**Aeroplane DA 42**

Exchange of the Wing Stub Safety Walks,  
Revision of the Airplane Flight Manual  
Single Engine Rate of Climb/Descent

# MANDATORY SERVICE BULLETIN

## NO. MSB-42-006/1

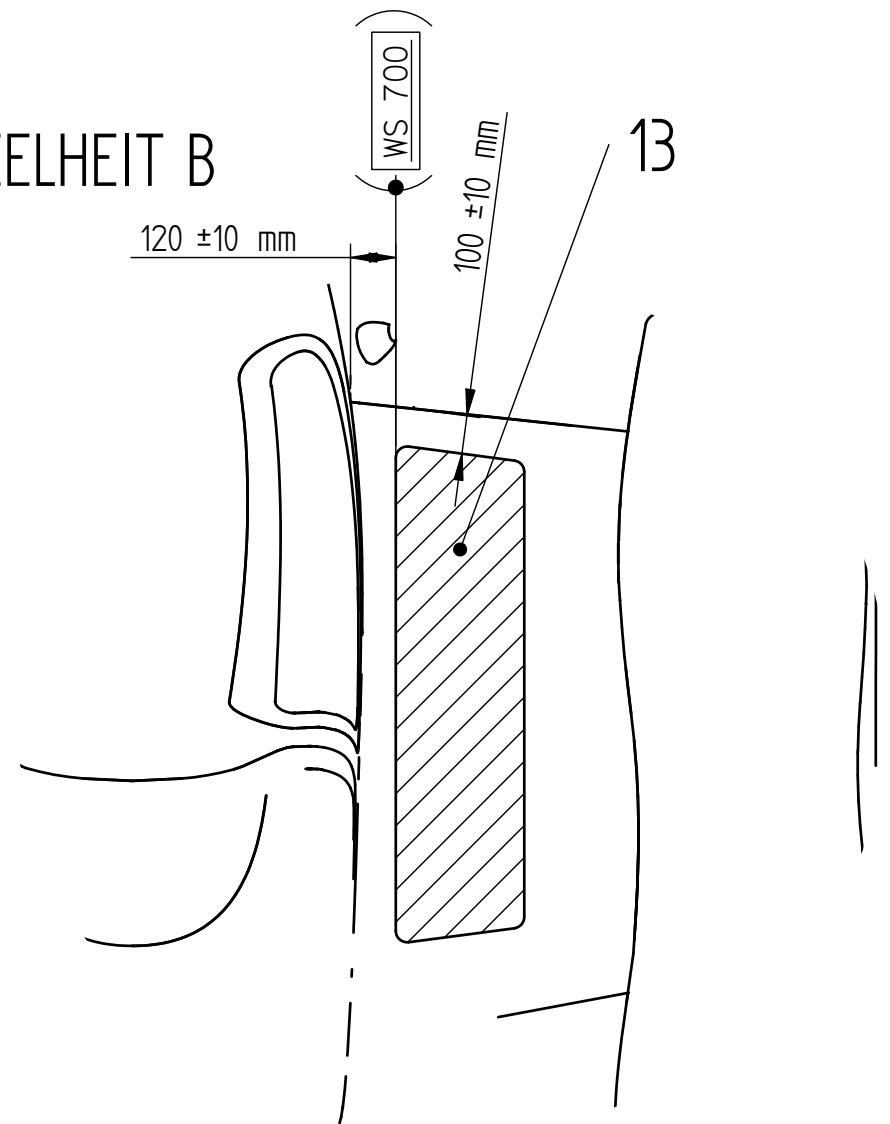
- a Remove Safety Walk Series 300, color grey – coarse surface (surface roughness equal to sandpaper with grid 40). For replacement refer to AMM, Chapter 11-00.
- b Install new Safety Walk D60-1127-10-51 Rev. “a” or later issue (surface roughness equal or finer than sandpaper grid 100) according to drawing D60-1120-20-00SB, latest effective revision. For replacement refer to AMM, Chapter 11-00.
- c Remove AFM-TR-MÄM-42-070, page 5-18a, and AFM-TR-MÄM-42-103, page 5-18b.
- d Mark AFM page 5-18 as superseded.
- e Incorporate Temporary Revision TR-MÄM-42-111/a into the AFM.
- f MSB 42-005 becomes obsolete with compliance to MSB 42-006/1 or later.

2 x D60-1127-10-51 Rev. "a" or later issue.  
Temporary Revision TR-MÄM-42-111/a is attached to this Service Bulletin.  
D60-1120-20-00SB is attached to this Service Bulletin.
